# Stability Pathfinder Phase 2 FAQ

Updated 29/10/21

This document contains the questions submitted at the RFI stage from July 2020. We have updated some of the responses to reflect the latest information. As the EOI progresses we will update this document with EOI webinar questions and common questions we are receiving.

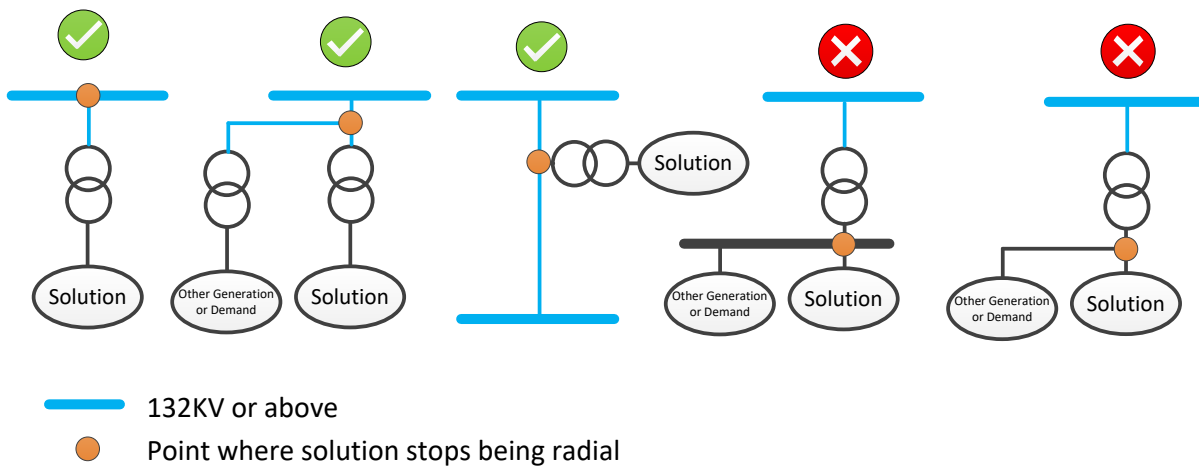
**30. Why were these 8 locations picked? (added 06/11/20)**

This is based on our system needs and studies. See Q13 for more information.
